# **Abo Canyon Engineering Study**

## **The Tunneling Option**

**Project:** Proposed BNSF Railway Company Second Track through the Abo Canyon and DS Ranch, LLC

**Subject:** Alternative solution - Tunneling option

**Figure 11:** Twin tracks in a single tunnel

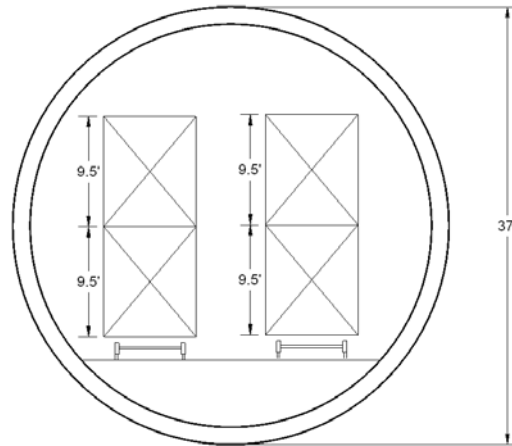
As twin tracks in a single tunnel is rarely done for long tunnels due to difficulty with ventilation, twin single tunnels are generally considered a more viable solution. Figures 11 and 12 show two possible railroad tunnel configurations.

**Figure 15:** North and South tunnel alignment options

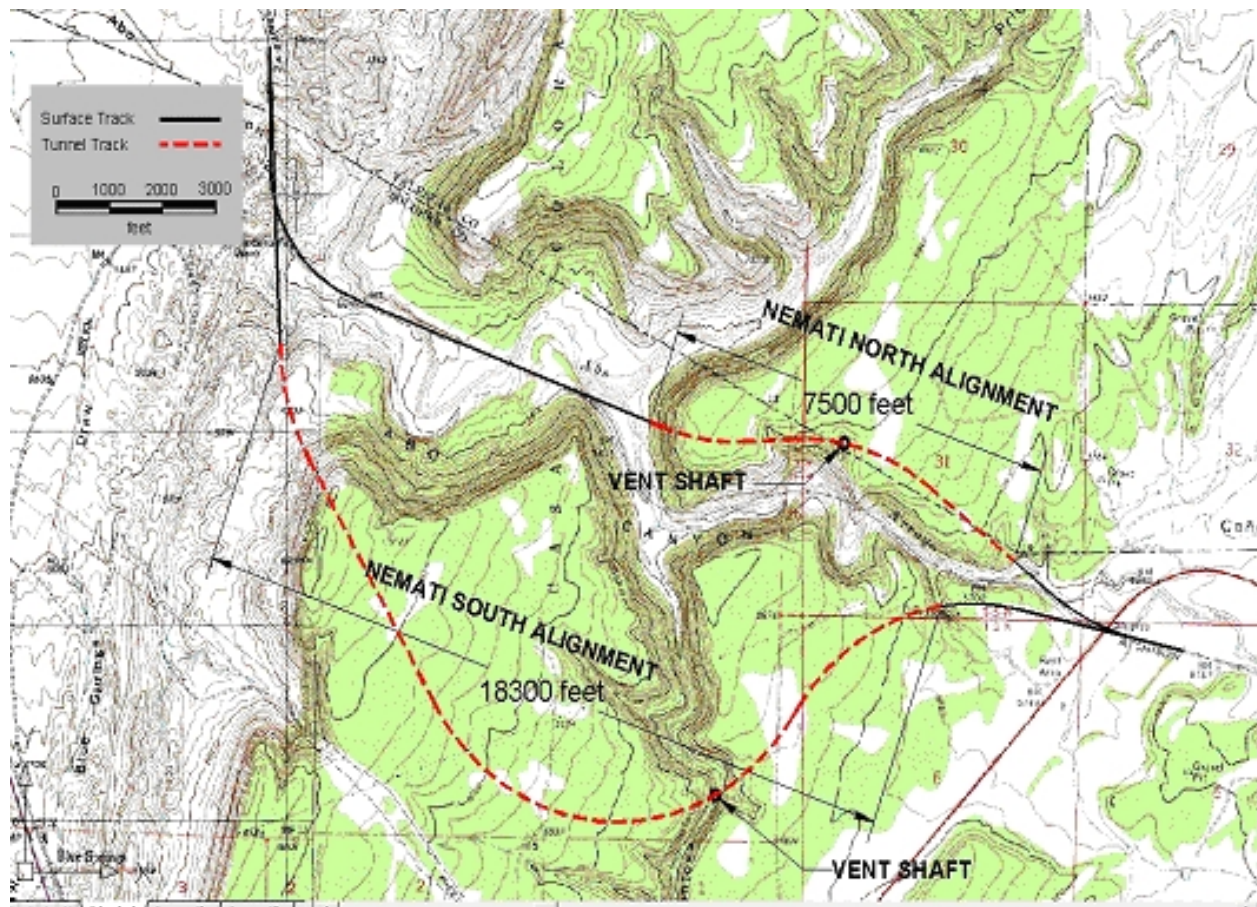
Figure 15 shows two possible tunnel alignments for Abo Canyon: “Nemati North” and “Nemati South”. These alignments are very conceptual in nature and are provided only in an attempt to illustrate that there are other viable ways to meet the need for a second railroad track through this area.

Of the two tunnel alignments shown in Figure 15, one stays completely out of Abo Canyon and is referred to as “Nemati South” alignment while the other avoids the narrower reaches of the canyon and is referred to as the “Nemati North” alignment.

The length of the south tunnel alignment is approximately 3.5 miles (18,300 feet). The criteria used to determine this alignment was to maximize train speed by using less than 1.5 degrees of curvature (4000 foot radius) while at the same time staying out of the Montosa Arroyo. As the result, the proposed south alignment swings a considerable distance south. This tunnel alignment can be constructed using grades of less than 1.5%. The existing alignment contains curves with greater than 2 degrees of curvature (curve radius of 2700 feet), and thus forces the trains to pass at much slower speeds. The grade of the south tunnel option can be maintained at less than 1.5% which would reduce the fuel consumption of the locomotives. The combination of this lower grade and flatter curvature means that the trains can travel with speeds of up to 60 miles per hour, which is substantially faster than the speed that the trains travel through the canyon with the existing alignment. The location of a ventilation shaft associated with this tunnel option is indicated on Figure 15.

With this option, the railroad would utilize the existing railroad right-of-way and parallel the existing alignment over bridges 1 through 4 (see Figure 1). The alignment remains on the surface in the flat portion of the alignment and then enters a tunnel on the north side of the narrow reaches of Abo Canyon to the east (Figures 16 through 18). With this option, the length of the tunnel is reduced to 1.4 miles (7,500 feet) and an associated ventilation shaft can be constructed at a midpoint of the tunnel (Figure 19). Similar to the south tunnel alignment option, the north tunnel alignment option can maintain a grade of less than 1.5% and the track curvature can be held to less than 1.5 degrees of curvature. This combination of low grades and flat curves will result in much higher speeds of travel and increase throughput for BNSF.
